MONTGOMERY COUNTY PLANNING DEPARTMENT
THE MARYLAND-NATIONAL CAPITAL PARK AND PLANNING COMMISSION

MEMORANDUM

PROJECT: West Cedar Lane Shared Use Path
From Old Georgetown Road (MD187) to Wisconsin Avenue (MD355)
CIP No. 501000

REVIEW TYPE: Mandatory Referral No. MR2010812

Attachment 3

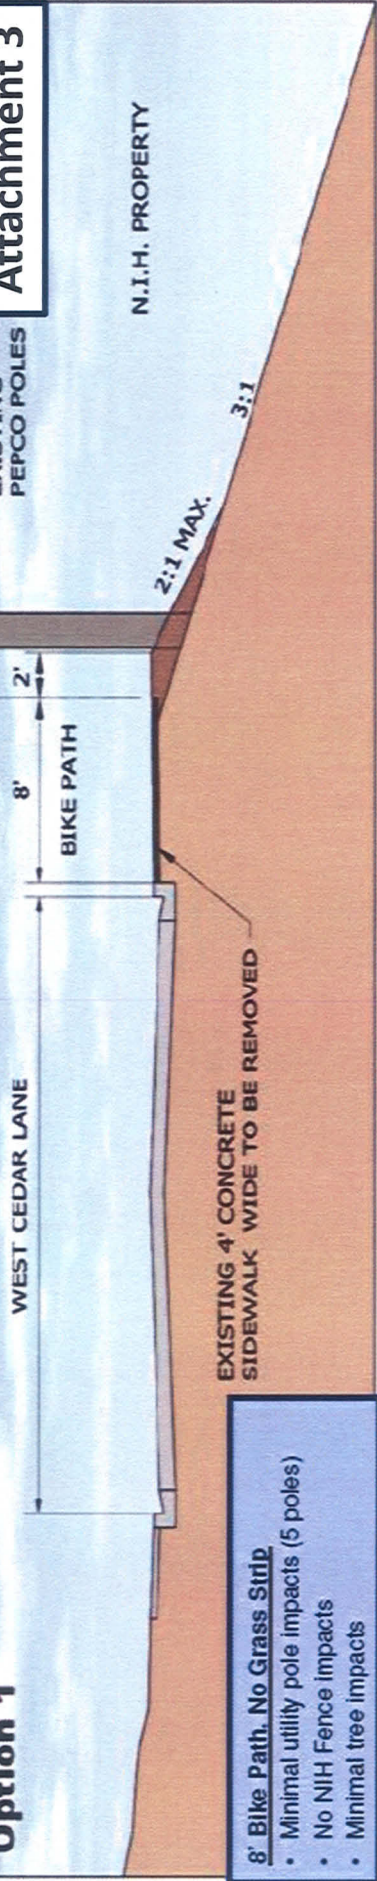
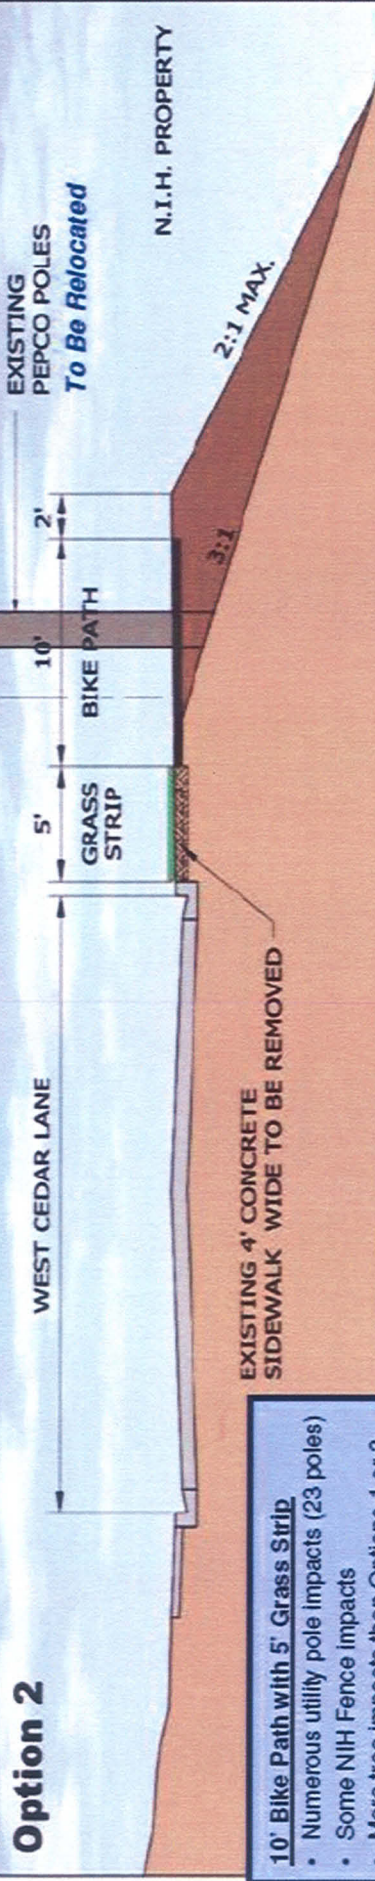
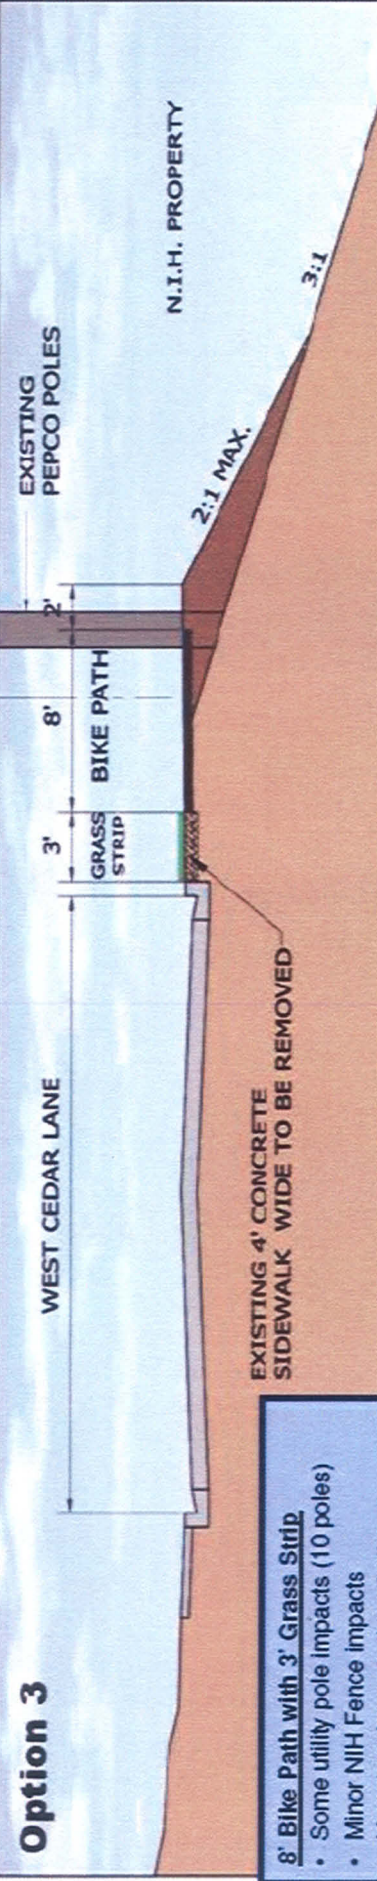
The proposed typical section is a modified amalgam of two of the alternatives shown to the public in March 2010 (see Attachment 3). Option 1 showed an eight-foot-wide path at the curb with a two-foot-wide offset to the utility pole, and Option 3 showed an eight-foot-wide path at the curb with the utility pole embedded one foot into the path. Option 2 that moved almost two dozen utility poles was the only option that would achieve a path that meets current standards. In addition to the significant cost of moving the poles, the additional impacts to trees were also a consideration in MCDOT’s decision not to choose this option.

Reallocating six feet of space in the typical section from the north side parking lane to the south side bike path would enable:

- The buffer width for the path to be increased from two feet to three feet
- The path width to be increased from eight feet to ten feet, and
- The minimum distance between the path and the utility poles to be increased from zero feet to three feet
